REGULAR OPEN MEETING OF THE UNITED LAGUNA WOODS MUTUAL ARCHITECTURAL CONTROL AND STANDARDS COMMITTEE*

**Thursday, November 16, 2023 – 9:30 a.m.
Laguna Woods Village Board Room /Virtual Meeting
24351 El Toro Road, Laguna Woods, CA 92637**

DATE: November 16, 2023
FOR: Architectural Control and Standards Committee
SUBJECT: Revision to Standard 18: Gutters and Downspouts

ATTACHMENT 3 – REDLINED REVISED STANDARD 18:
GUTTERS AND DOWNSPOUTS

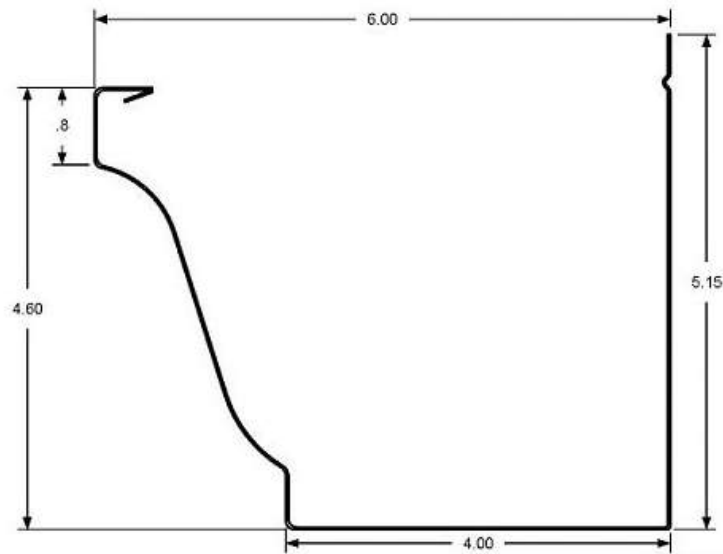
2.4 All gutters are to be 6-inches wide as measured across the top. Gutters are to be made of aluminum with a minimum gauge of .027. Vinyl coated aluminum is permitted copper and steel gutters or downspouts are not permitted. Gutters are required to slope one inch for every 20 feet toward the downspout.

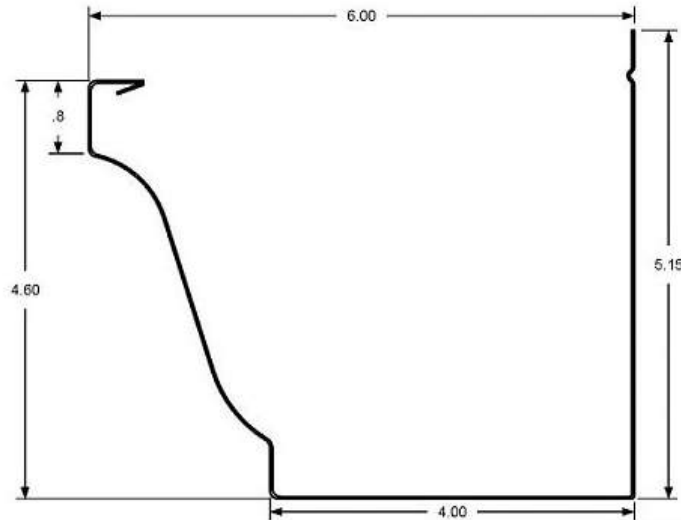
- 2.1** All gutters and downspouts shall have a slope of not less than 1/8-inch per foot along their entire length. Gutters and downspouts shall be installed so that water does not pool at any point.
- 2.2** Downspouts shall be installed along every 25 feet to 30 feet of guttering. No downspouts may be installed that will drain into an area that will effect surface drainage in an adverse way.
- 2.3** Installations to roof systems where hangers penetrate or may harm the roofing material in any way are prohibited.
- 2.4** All gutters are to be 6-inches wide as measured across the top. Gutters are to be made of aluminum with a minimum gauge of .027. Vinyl coated aluminum is permitted copper and steel gutters or downspouts are not permitted.
